Floyd Hill Design - Technical Team

Meeting Summary

June 24, 2022, 9 AM to 12 PM

Preferred Alternative:

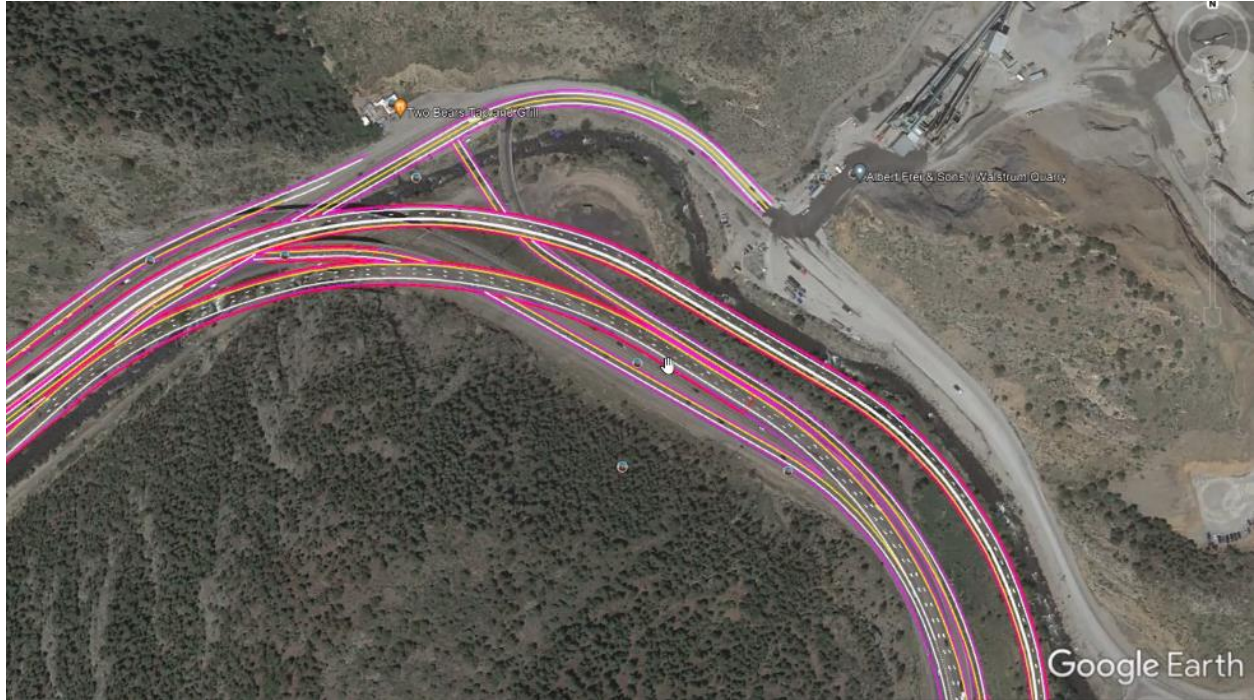
The design team noted challenges with the existing Preferred Alternative. The hillside to the south of the highway is steep, creating potential construction challenges. Construction of the off ramp to US 6 would be particularly challenging given the location and size of the off ramp. TT members provided context on the size increase from the existing infrastructure to the Preferred Alternative, saying that currently from Two Bears Bar and Grill to the road is 30’, but this distance would be doubled to 60’ in the Preferred Alternative.

- **TT Question:** What is the tallest pillar of the viaduct in the Preferred Alternative?
 - **Design Team Response:** 140’

Preferred Alternative (left) vs. Innovation (right)

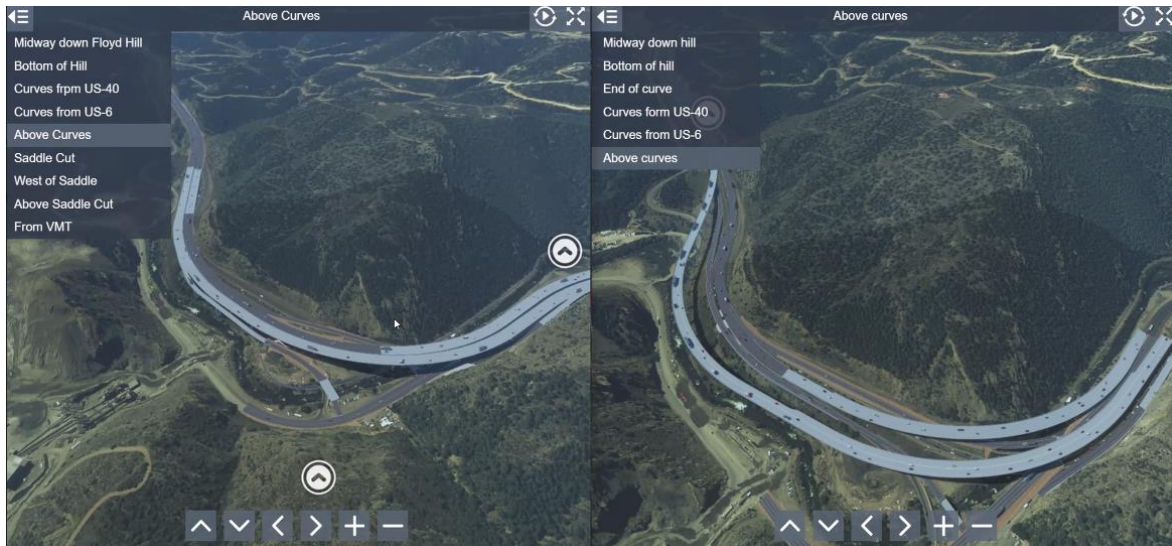
- **TT Question:** What is the landslide risk for this area?
 - **Design Team Response:** The Project has a team analyzing landslide risk. Moving the columns of the viaduct to the bottom of the hill decreases the risk. It was determined during the 20% Design Phase of the project that the landslide existing in the area is “off limits.”

- **TT Question:** Would there be a difference in noise impacts for residents between the alternatives?
 - **Response:** The innovation may decrease noise impacts due to the highway being further away from residential areas, but a full analysis should be conducted.

- **TT Question:** Are there significant differences in access to the creek between the alternatives?
 - **Response:** There are no significant differences.

- **TT Question:** Has there been traffic flow modeling showing differences between the alternatives?
 - **Response:** There are no significant differences.
